Architectural Commission Report

Meeting Date: Wednesday, April 15, 2015

Subject: **BANK OF AMERICA (PL1504799)**
9440 South Santa Monica Boulevard

Request for approval of a façade remodel, a business identification sign, a sign accommodation to allow a non-entry elevation sign to exceed thirty square feet, and a construction barricade graphic. The Commission will also consider adoption of a Categorical Exemption, pursuant to the California Environmental Quality Act.

1 PROPOSED
SCALE: N.T.S.

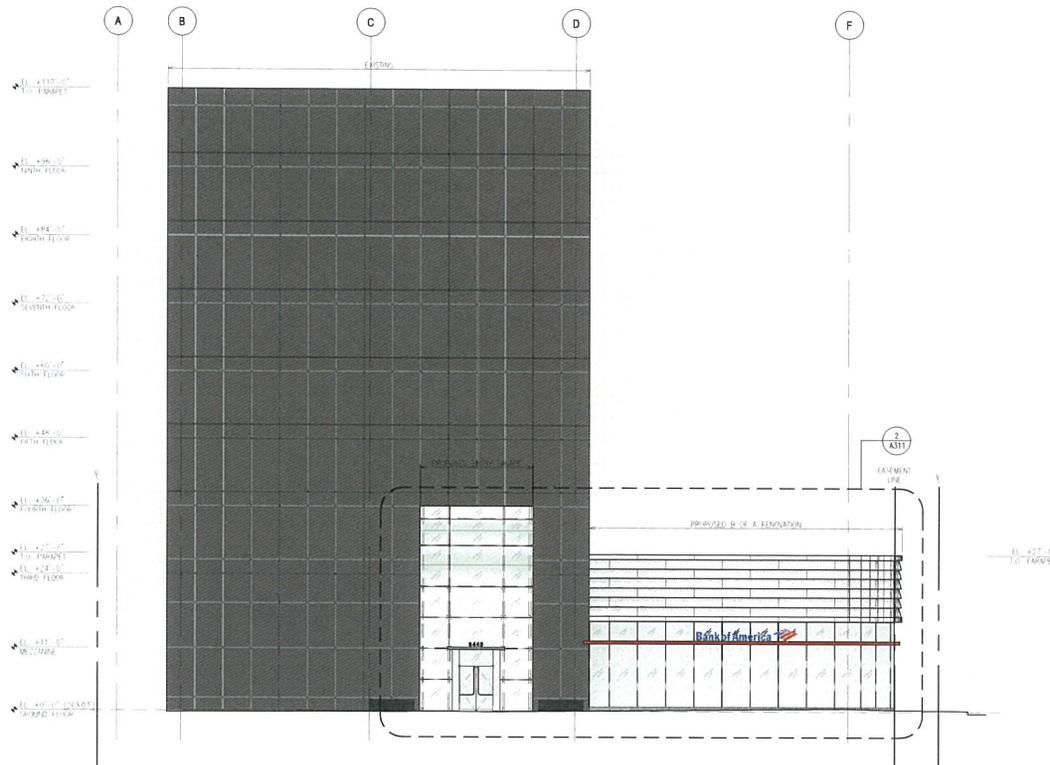
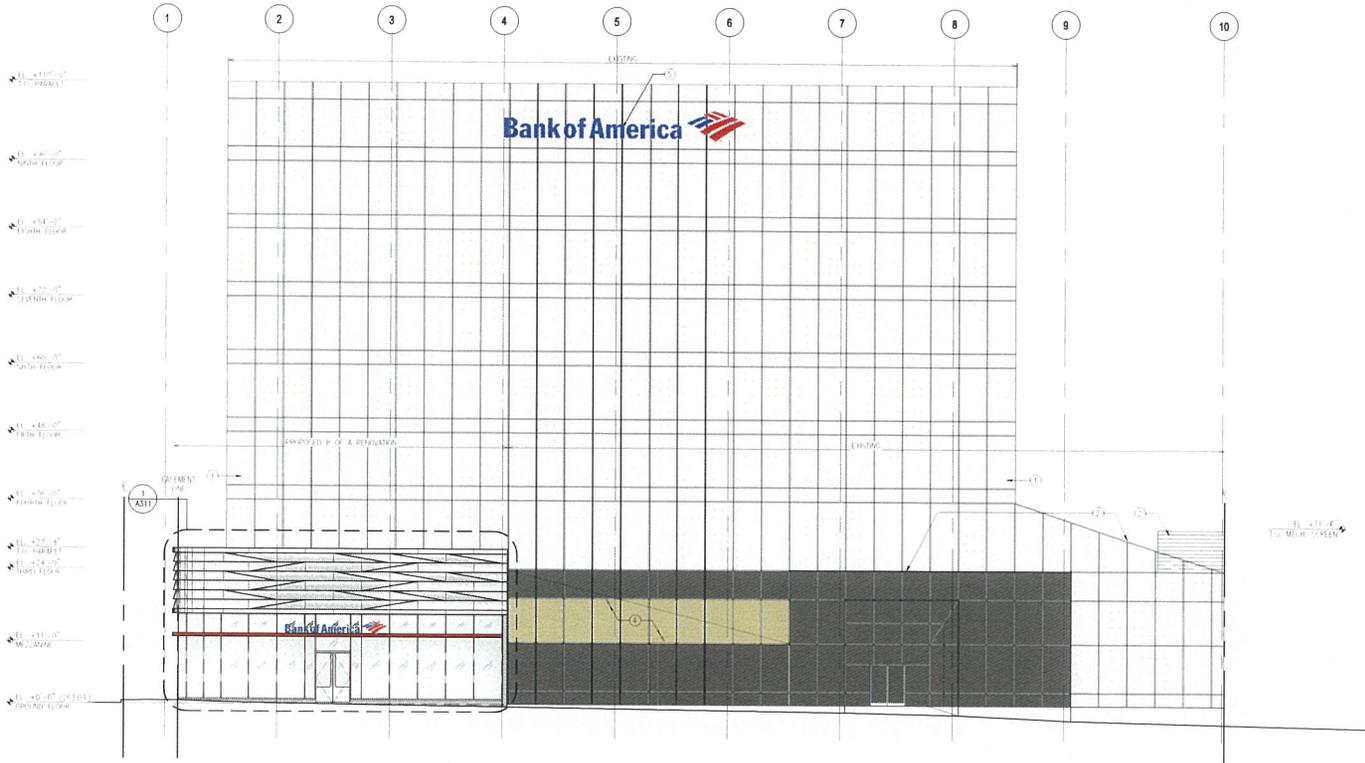
As a stand-alone design there is considerable merit in the proposed façade aesthetic, particularly in how it considerably increases the ground floor transparency; however, it fragments an otherwise coherent building. The proposed design does not relate to the overall building, which results in an awkward aesthetic at the corner and when viewed at a distance. It is recommended that the applicant consider incorporating a larger majority of the ground floor into the façade remodel so as to provide a consistent design aesthetic at the base of the building. While the ground floor would continue to contrast from the upper floors, it will be done in a more cohesive and deliberate manner.

1 BARRICADE PLAN
SCALE: 1/8"=1'-0"

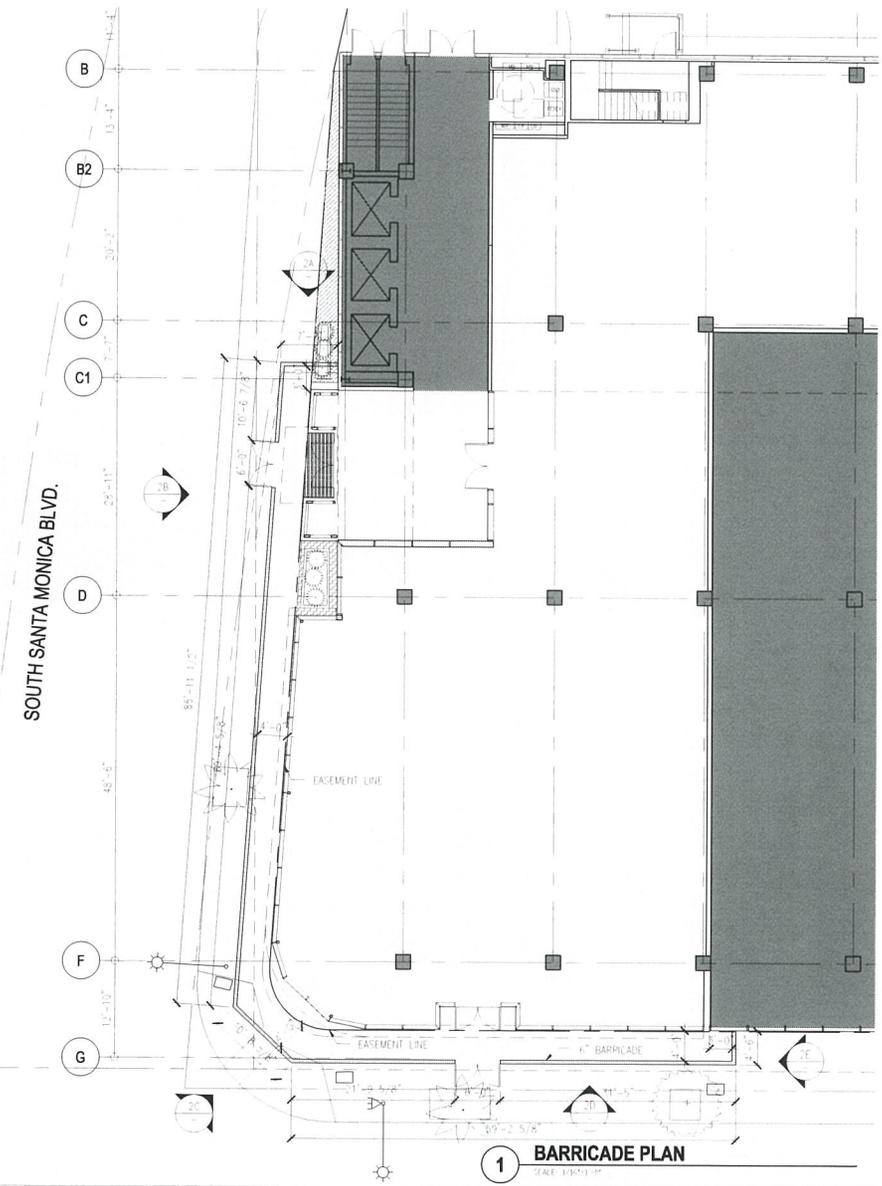
Additionally, the construction barricade graphic lacks imagination in its design and it is recommended that it be redesigned to a more artistic expression.
